## Arborist Site Inspection Impact Assessment

| <b>Address</b>                         | Village Green, Friday Drive THREDBO NSW                                      |

### Brief

Typical TPZ and 10% encroachment detail

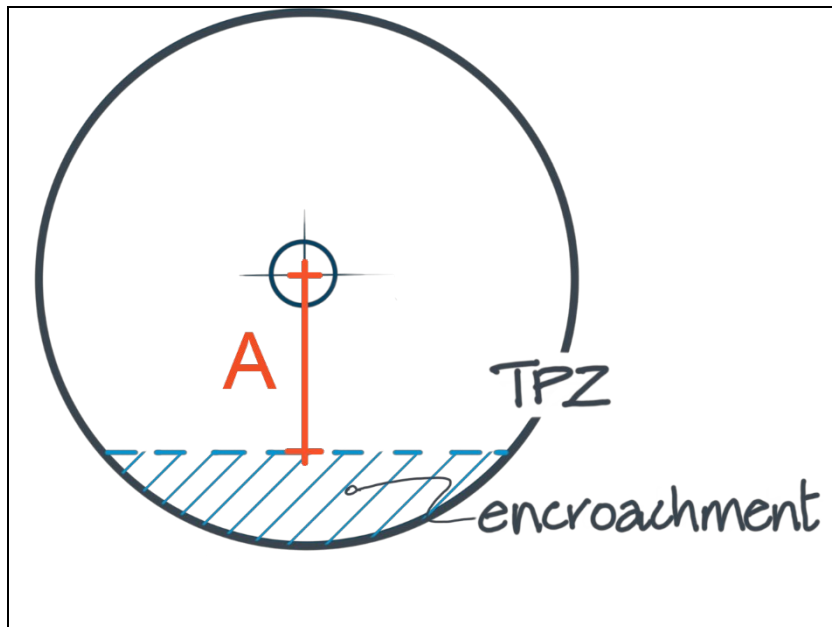
Any encroachment by mechanical trenching into the Tree Protection Zone (TPZ) that will cause damage to tree roots will have a negative impact on tree health and should be avoided. While a ten percent encroachment is permissible anything above this should be avoided. Any encroachment over thirty percent can cause partial decline or whole tree death.

A planned log slalom course will also encroach into the TPZ of tree 1. (See concept Plan)

This encroachment is 10 percent and is a permissible encroachment.

The proposed Log Slalom course must be redesigned so the line of encroachment does not come closer than 6.6m from the centre of the main trunk to minimise the encroachment area to 10% or less. The footing detail for the logs should be bored footings which will aid in avoiding continuous disturbance within the TPZ and limiting damage to sub soil roots.
